SERVICE TECHNICAL INFORMATION

ONE POINT REPAIR

MODEL : TV-1402KE/2002KE/2102KE

SUBJECT : Part Number of EEP ROM (IC002/NVM3060)

Fig-1

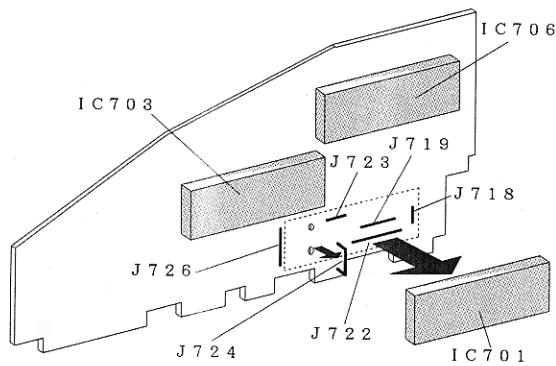
1. Remove IC701, IC703, and IC706. (See Fig. 1.)
2. Remove all jumper lines mounted under IC. (See Fig. 1.)

Under IC701:	J718/ J719/ J722/ J723/ J724/ J726	} Total of 22 lines.
Under IC703:	J746/ J747/ J748/ J749/ J751/ J752/ J792	
Under IC706:	J754/ J757/ J758/ J759/ J760/ J761/ J762/ J763/ J764

DIGITAL C.B (side with mounted parts)
As shown in the diagram, remove the ICs and then remove each jumper line.

Fig-2

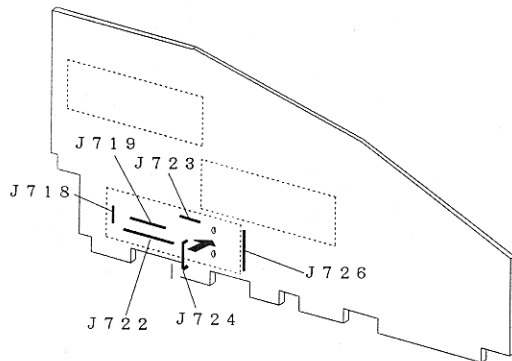
3. Attach the removed jumper lines to the pattern surface on the reverse side. (See Fig. 2)

DIGITAL C.B (Pattern side)
Attach the removed jumper lines to the pattern surface and solder. At this time, make sure that jumper lines are not too long that they protrude over to the side with the mounted parts.

X701 Waveform

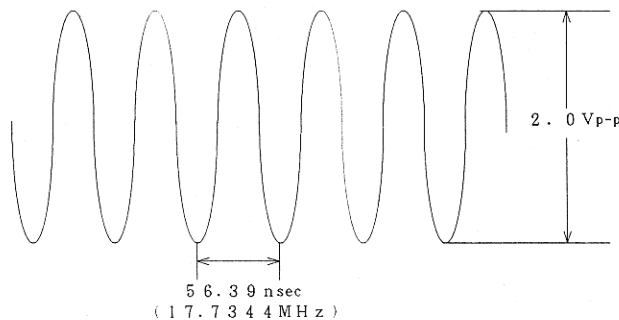
There have also been many cases of faulty X701s and faulty soldering. When repairing DIGITAL C.B, always confirm that X701 operates correctly. (See below.)

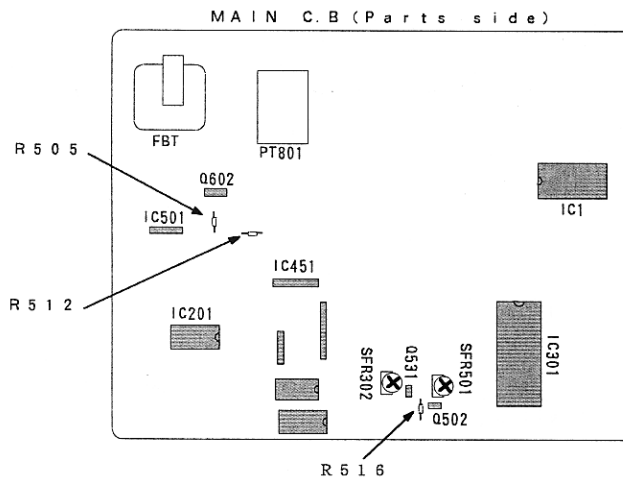
ACTIONS : Replace the three resistors shown below.

R505	R512	R516	
Existing	82K-1/8W	1.8K-1/8W	180K-1/8W (*)	Correct value is 180K-1/8W. "180-1/8W" in S/M circuit diagram is wrong.
	↓	↓	↓	
After replacement	39K-1/8W	1.2K-1/8W	270K-1/8W

Ref.	Part name	Part number
R505	RES, 39K-1/8W J	88-121-393-080
R512	RES, 1.2K-1/8W J	88-121-122-080
R516	RES, 270K-1/8W J	88-121-274-080

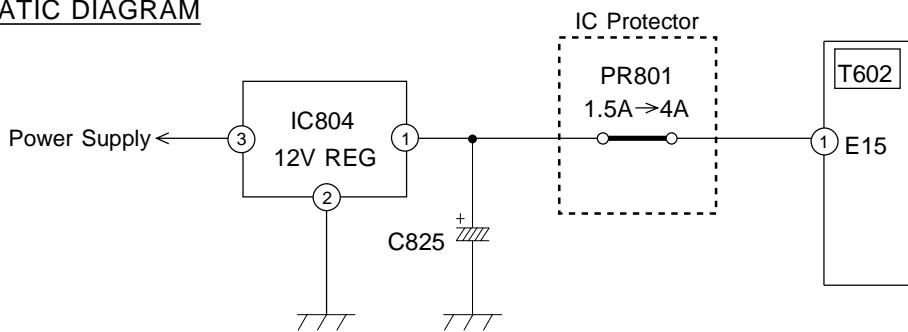
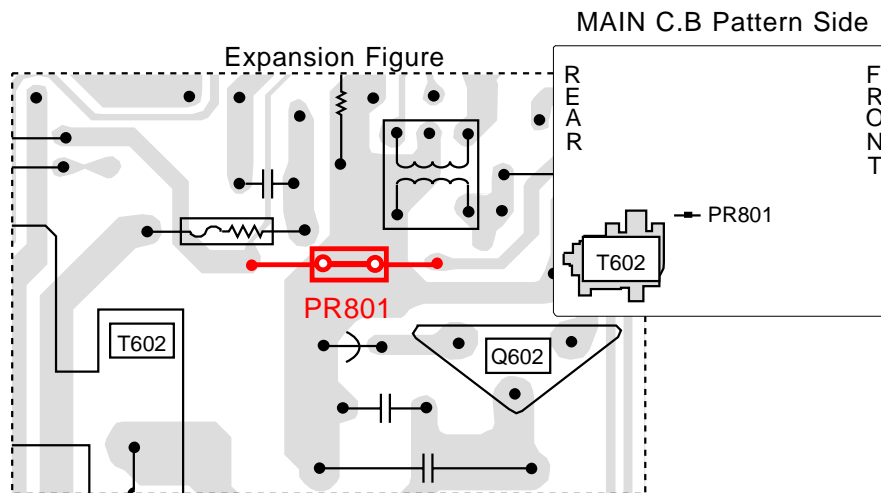
No power due to open IC PROTECTOR (ICP,PR 801) caused by a rush current.

Replace the IC Protector (PR801 1.5A)with one that has higher current capacity(4A).

Ref.	Parts Code	Description	Remarks
PR801	87-A90-094-080	PROTECTOR,4A 491SERIES 60V	-

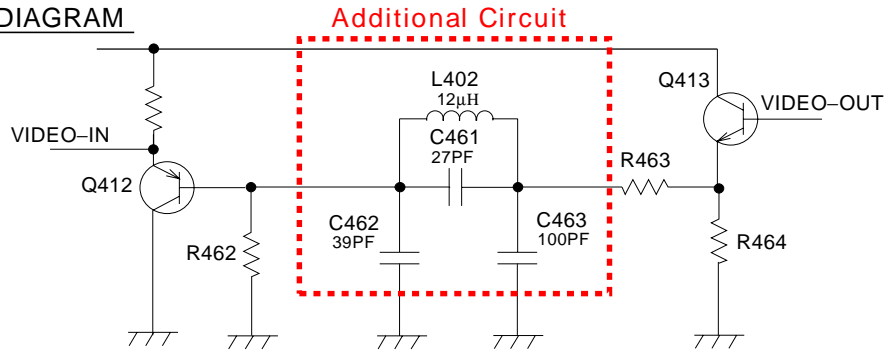
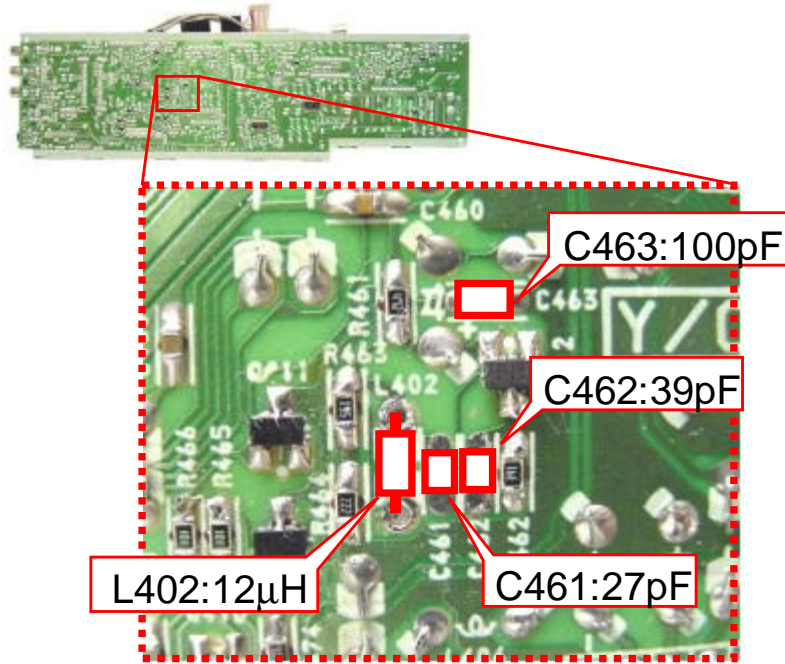
A vertical line may appear on TV screen when VCD player or DVD player is connected to input terminal for playback.

Add a filter (when fitting L402, remove jumper wire).

Ref.	Parts Code	Description	Remarks
-	SV-T00-117-01J	KIT,TV-F2100/F2500 V NOISE	-

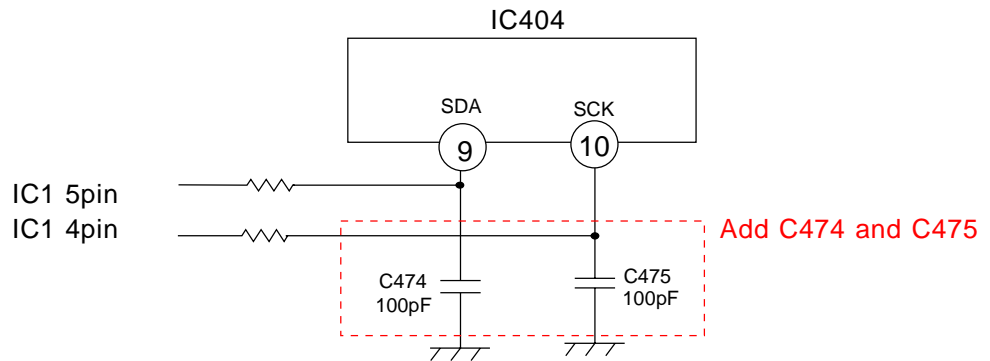
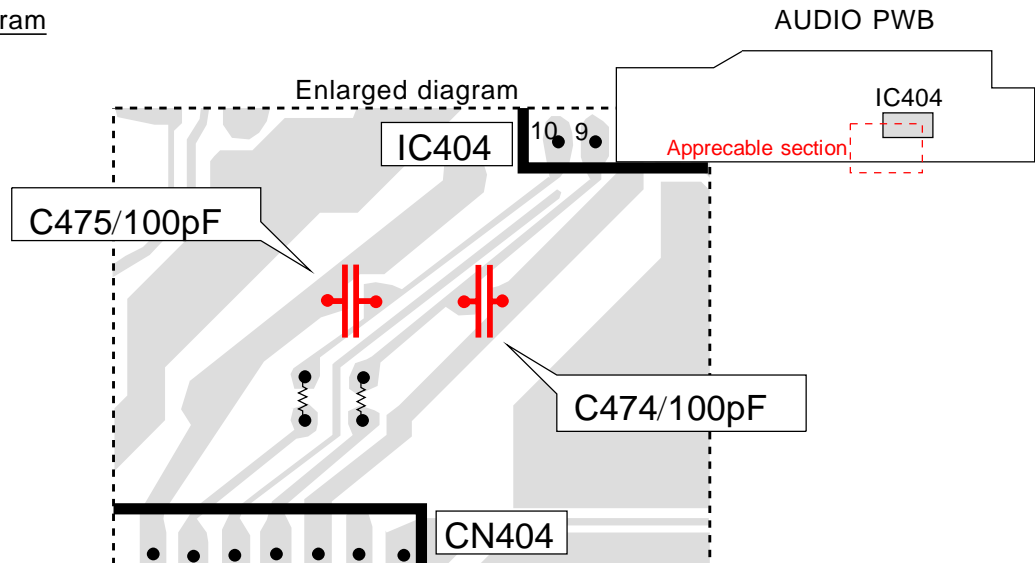
Noise enters into the data line(SDA/SCK) of IC404(volume controller) and causes the following symptoms.

Add a capacitor to the data line(SDA/SCK) of IC404(volume controller) and compose a noise filter(Lands are available).

Ref.	Parts Code	Description	Remarks
C475,C474	87-010-322-080	C-CAP,S 100P-50 J CH GR	-

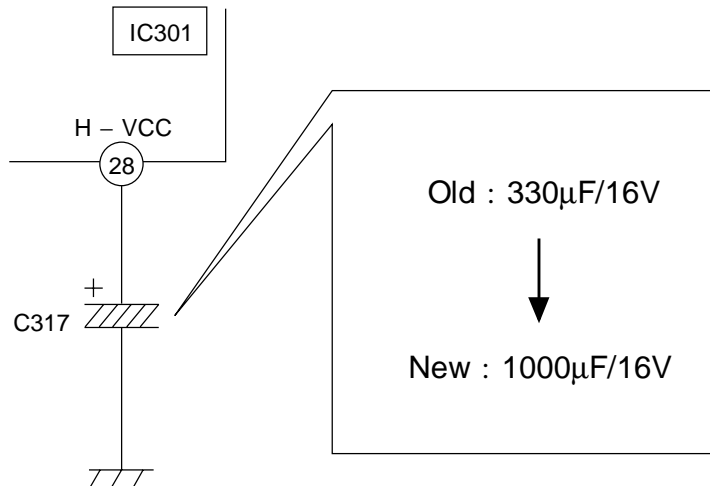
Black marking appear as shown below.
Appearing point defers according to the set.

1. Replace C317(330 μ F/16V) to 1000 μ F/16V(87-A10-730-080) regardless the symptom.
2. If already CRT burned in, replace to new CRT.

Ref.	Parts Code	Description	Remarks
C317	87-A10-730-080	CAP,E 1000-16V SMG	-

Fig1

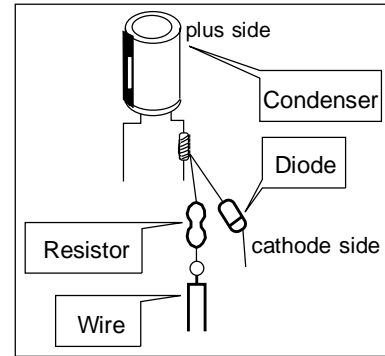
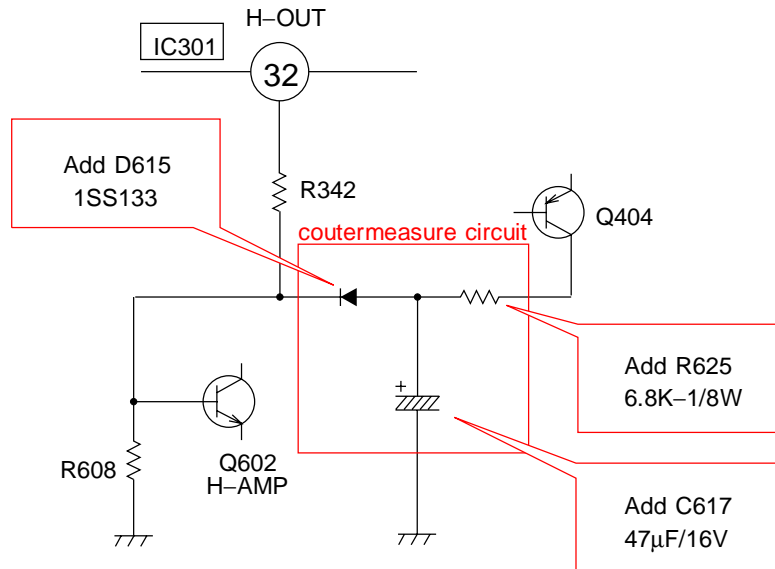
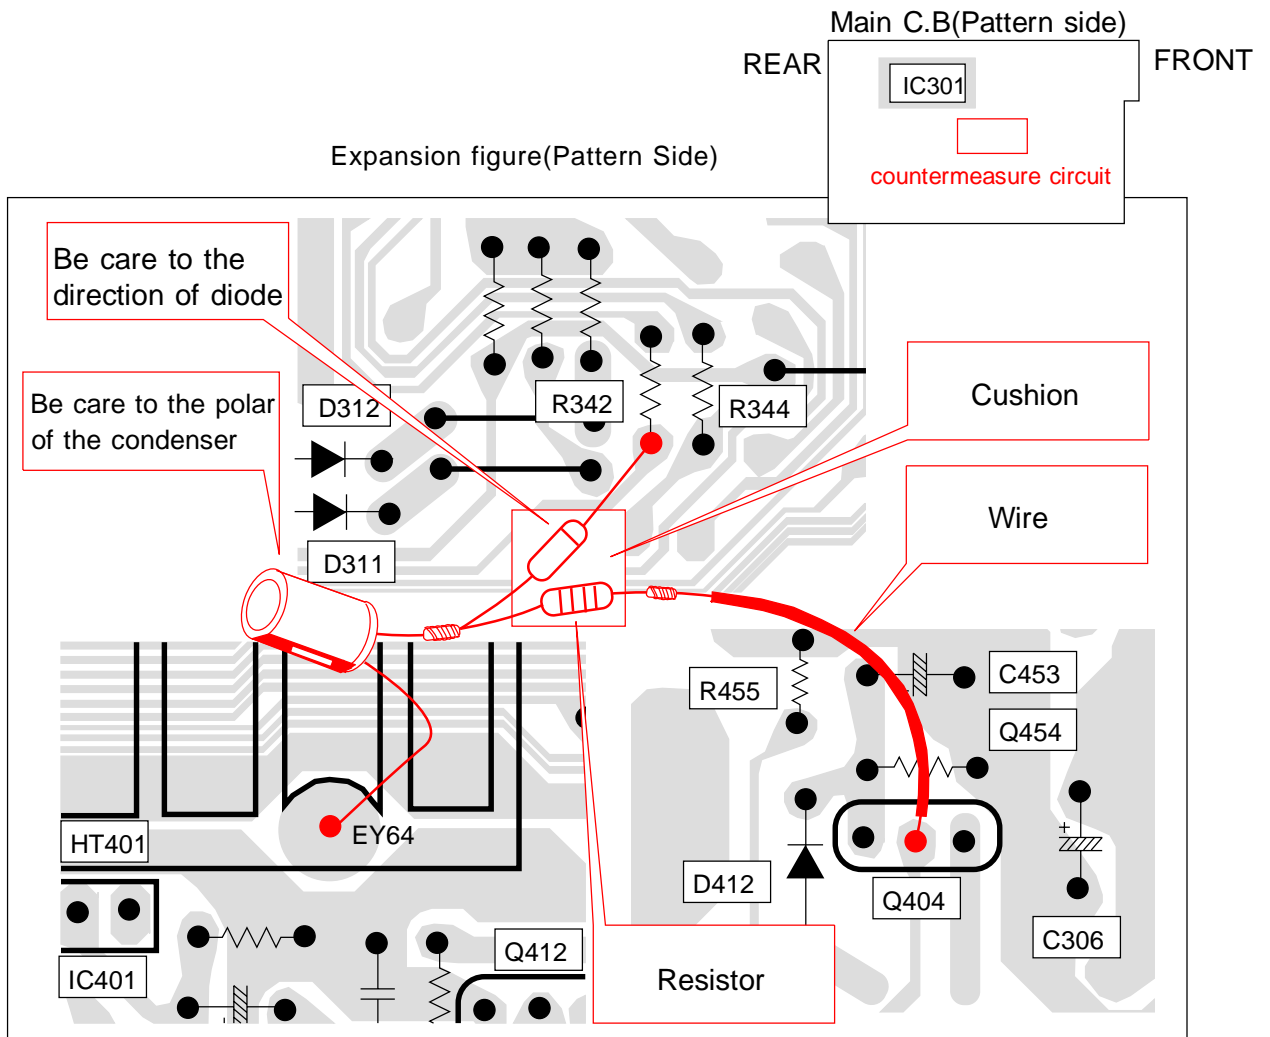
No power on due to horizontal output transistor Q601 failure.
Take the following countermeasure in this case.

Prevent the damage of Q601 by adding the curcuit.

1. Replace Q601 after confirming PR801 is open.
2. Connect condenser, diode, resistor, and wire according to the drawing 1.

Be care to the direction of diode and condensor.

3. Attach the circuit 2 to the rear of main board.(Refer next page)

Ref.	Parts Code	Description	Remarks
-	SV-T00-118-010	KIT,ZJA-19 No Power	-

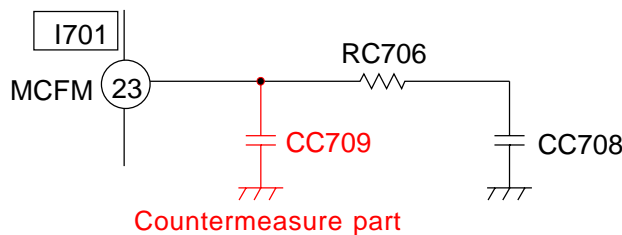
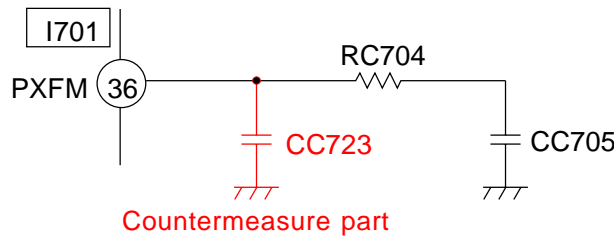
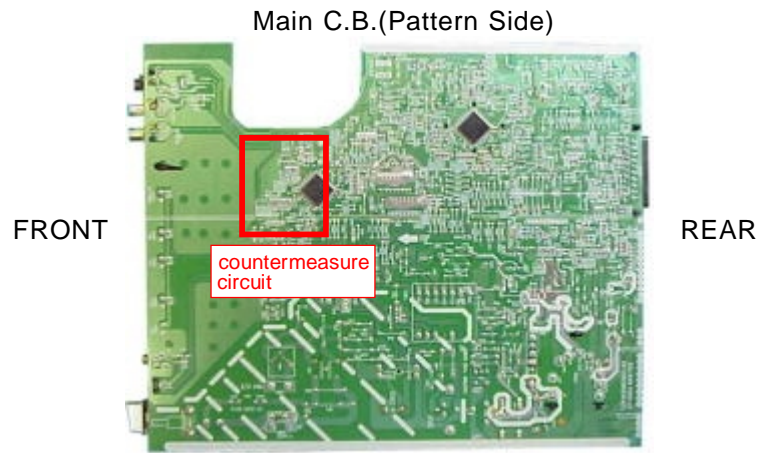
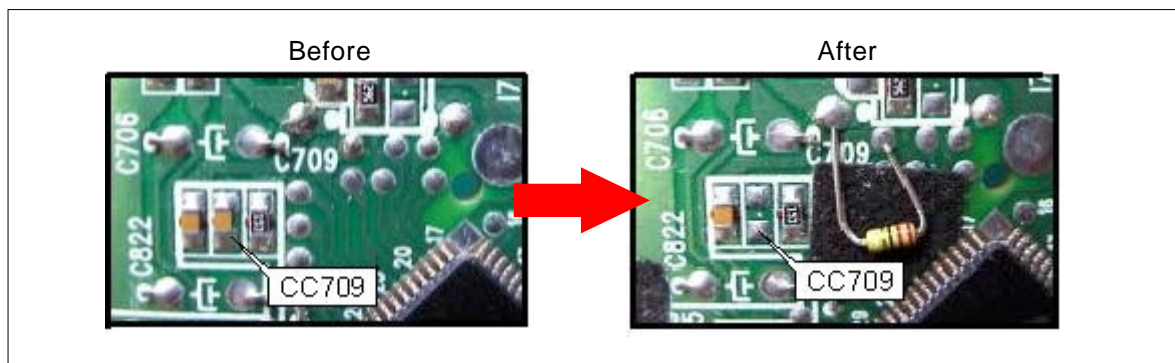
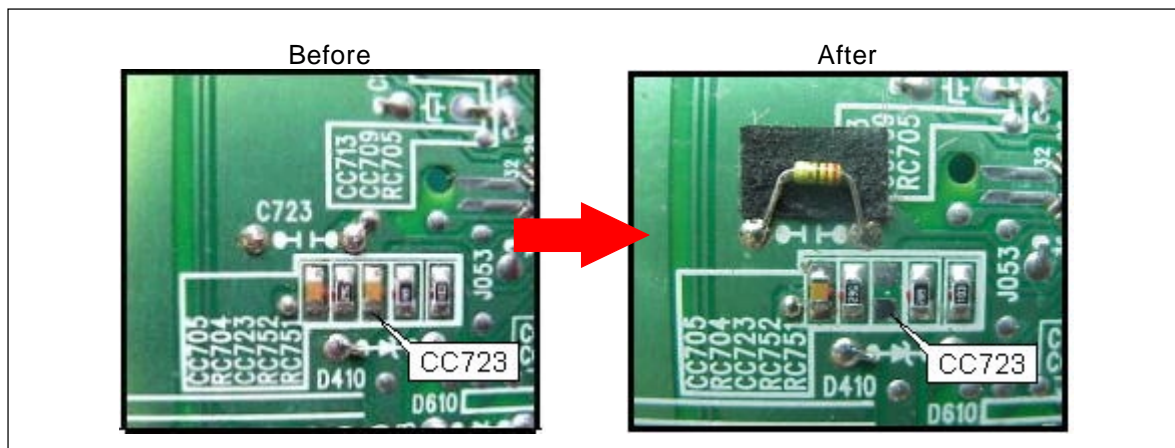
It may happen that " OSD does not display, standby LED does not light " as the flux causes to change the capacity of CC709,CC723.

By replacing the condenser CC709,CC723 from chip type to AXIAL type, the effect of flux reduces.(Please refer the next page for actual installation)

1. CC709 improvement point

Remove chip type condenser.

Attach adhesive cloth or cushion and put AXIAL type condenser.

2. CC723 improvement point

Remove chip type condenser.

Attach adhesive cloth or cushion and put AXIAL type condenser.

Ref.	Parts Code	Description	Remarks
CC709,CC723	87-A11-073-080	CAP,TC U 22P-50J CH

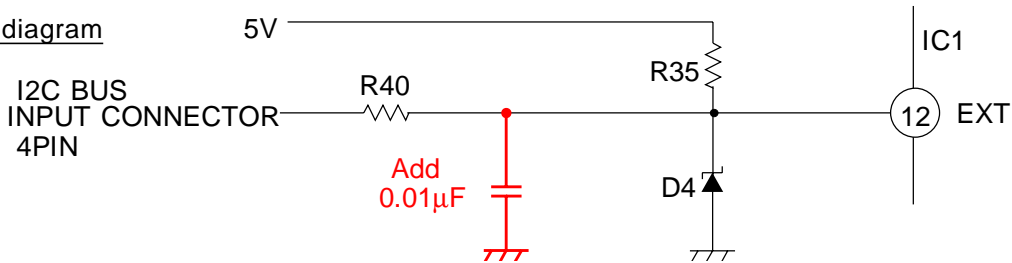
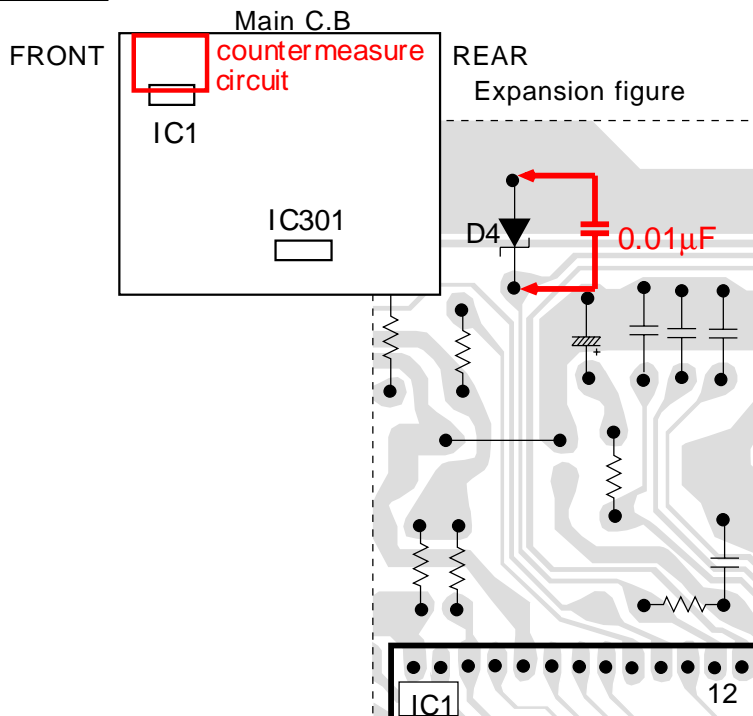
Power may off automatically due to the malfunction of 12 PIN (EXT terminal) of IC 1(micro processor)
In this case, please take the following corrective countermeasure.

Micro processor may occur malfunction due to the noise of EXT terminal.
To prevent malfunction, attach the condenser 0.01μF parallel to D4 on the reverse side.

*Be sure with glue after attaching the condenser.

Ref.	Parts Code	Description	Remarks
-	87-A11-132-080	CAP,TC U 0.01-50 K B	-

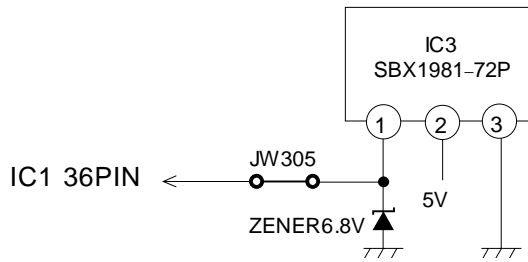
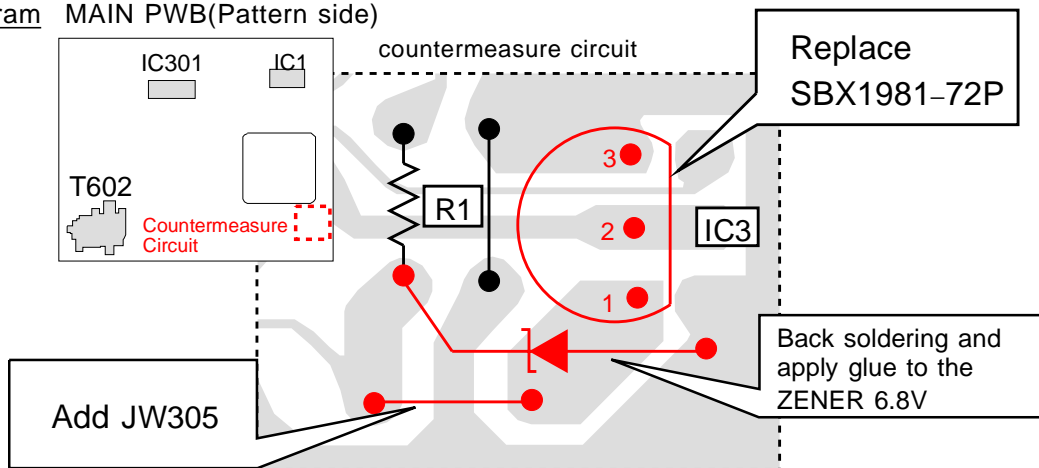
Due to malfunction of sensor part of remote controller(IC3), it may does not work properly.
In this case, take the following corrective countermeasure.
(Corrected set is dotted at the right side of serial No.)

1. Replace IC3 from GP1U281Y to SBX1981-72P.
2. Add JW305 following the drawing(land exists).
3. Back solder ZENER,UZ6.8BSC following the drawing.
Glue(KE-3490) on the parts.
4. Put the dot mark at the right side of serial No. after countermeasure.

Ref.	Parts Code	Description	Remarks
-	87-A40-754-080	ZENER,UZ6.8BSC	-
IC3	87-A91-538-010	RCR UNIT,SBX1981-72P	-
